Planning Application S/2876/16/OL - Development off Rampton Road, Cottenham

Cottenham Parish Council has considered the recently submitted revised **Transport Assessment, Travel Plan** and **Heritage Impact Statement** and offers these comments in support of its continued strong objection to the development.

Fig 2: Proposed “improvement” to Oakington Road / Rampton Road roundabout

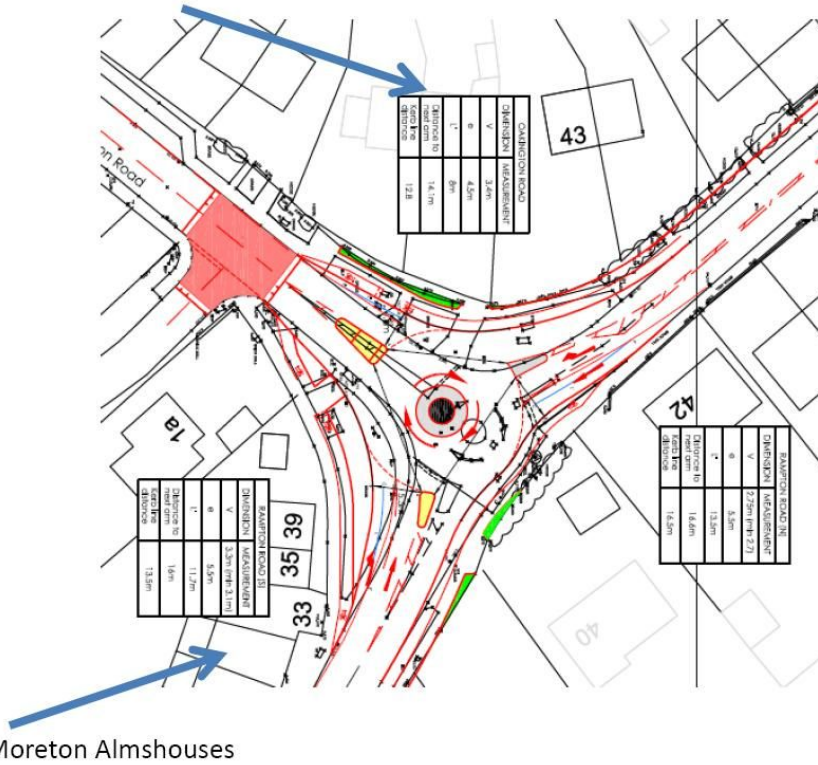
The Gladman-proposed solution has serious consequences for residents of Rampton Road, some of Oakington Road – especially #2 and #4 whose driveways would enter the new roundabout directly – and the Grade II Listed Buildings - the John Moreton 1853 Almshouses.

The proposed changes inherently affect the views to and from the Listed Buildings (4.38 of the SDC SPD “Listed Buildings: Works to or affecting the setting of”

Fig 4: Illustrative view of the effect on the setting of the almshouses (on left of diagram)

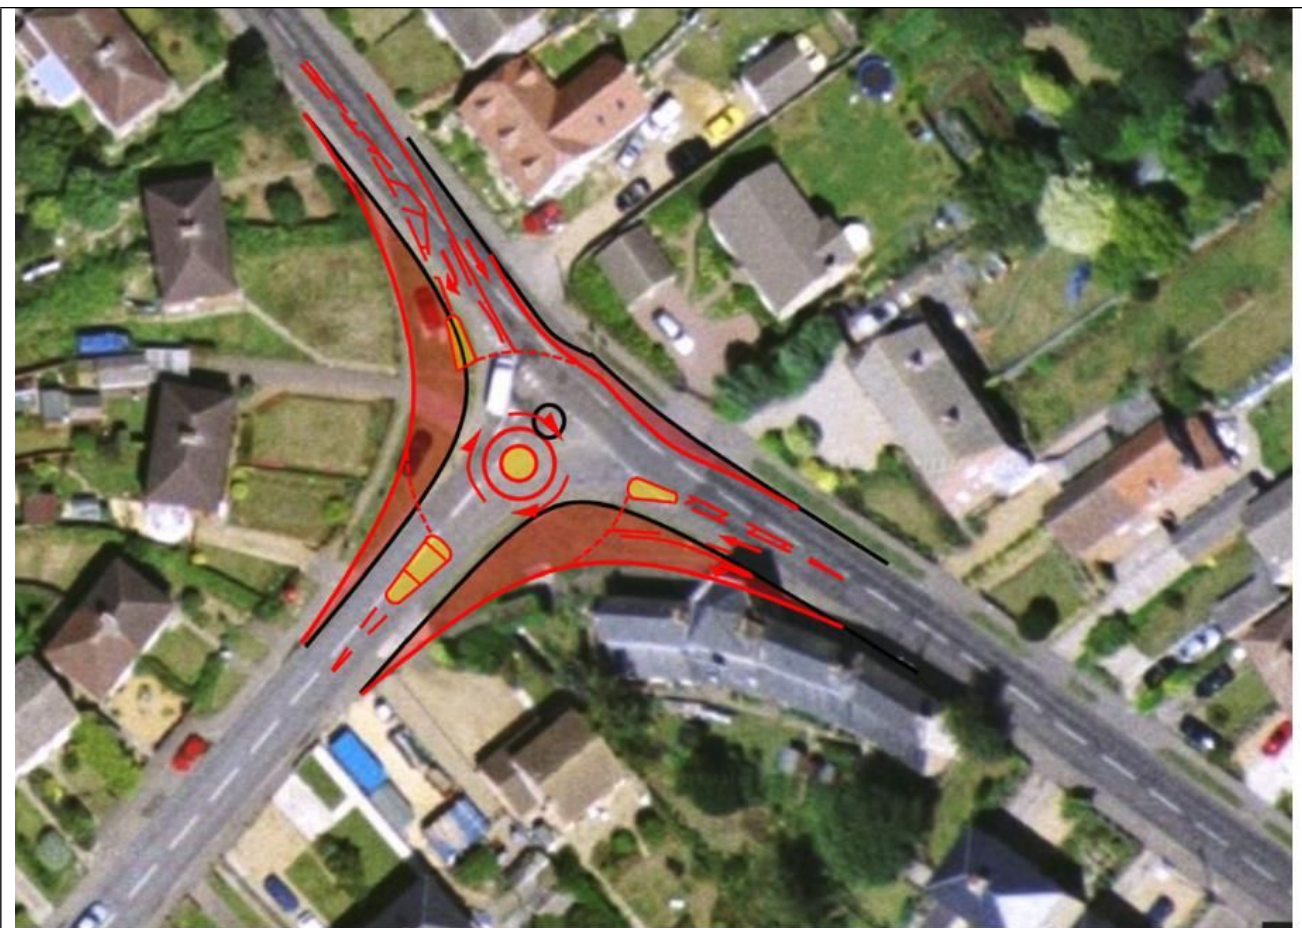
This roundabout is within the setting of the **Grade II listed 1853 Moreton almshouses** and, with the loss of its village green, would bring much more traffic closer. Increased vibration will compromise these foundation-less buildings. Cyclists and residents, especially the elderly residents of the almshouses (#25-#39 Rampton Road) but also the properties that front directly onto the existing roundabout (#40, #42, and #43 Rampton Road, #2 and #4 (Oakington Road)) will be exposed more intimately to more noise, pollution, and safety threats. especially by larger articulated vehicles manoeuvring around, and often across the roundabout. The number of elderly neighbours to the roundabout must require a higher than usual standard of road safety, otherwise these seven, otherwise truly affordable, homes will become impossible to let to those who most need them, nullifying any supposed benefit from the handful of affordable homes possibly deliverable within 5 years as part of the proposal. The long-term social and economic viability of the almshouses themselves is threatened. These buildings are not a just historic work of art to be conserved and admired at a distance, they are homes to some of our most vulnerable residents whose quality of life is threatened.
